Residential Development at Crodaun,  
Celbridge, Co. Kildare

Stage 1 Road Safety Audit

Report Ref: p170099-DBFL-RP-D-0005

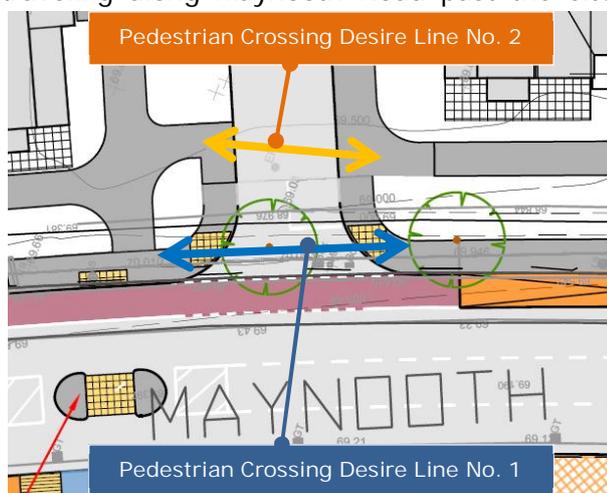
The drawings provided for this road safety audit do not provide any details in regard to the level of visibility splay that are available to vehicle drivers when seeking to exit the proposed new junction minor road. Failure to provide sufficient visibility for the drivers may result in overshoot incidents or side impact collisions with other road users.

Ensure appropriate levels of visibility splays are provided for all road users at the proposed access junction in reference to the 85<sup>th</sup> percentile of vehicle

speeds currently travelling in both directions along the Maynooth Road corridor in the area of the proposed site access junction.

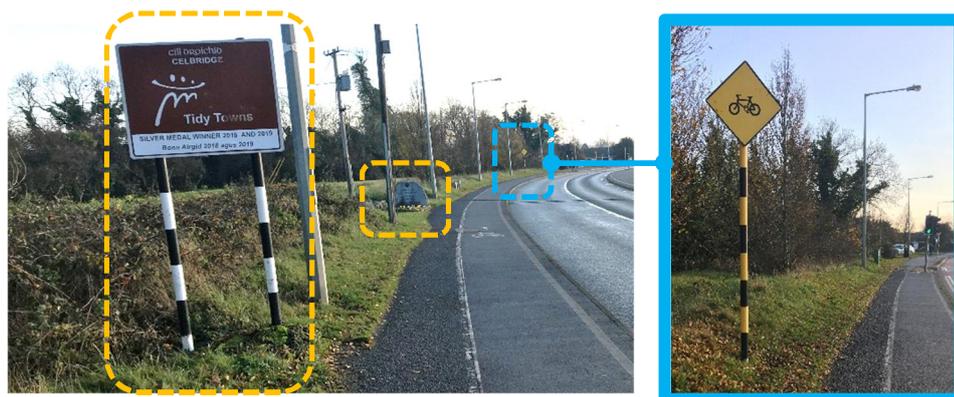
The auditors welcome the provision of a formal defensible pedestrian area within the centre of the Maynooth Road carriageway (immediately north of right turning lane). The implementation of the proposed pedestrian refuge area with solid raised islands either side will enable vulnerable road users to cross the road carriageway adopting a two-stage crossing process. The provision of these raised islands could also perform an important traffic calming role.

Nevertheless, the auditors are concerned that the modest size of the proposed raised islands (within the ghost islands hatched area) could make it difficult for vehicle drivers, particularly during dark and / or wet conditions, to clearly see and subsequently appreciate the presence of the raised islands from an appropriate distance away. If vehicle drivers can not clearly observe the raised islands when appropriating them, they may fail to proceed in an appropriate manner and speed which could result in them colliding with the island and / or other road users using the informal crossing facility.

It is recommended that the size (length) of the physical islands is increased and constructed using a material of contrasting colour to the road carriageway with the objective of enhancing the conspicuousness of the islands (and the pedestrian refuge / crossing facility on Maynooth Road) for vehicle drivers. Keep Left signs should also be provided at the nose and heel of the proposed traffic islands.
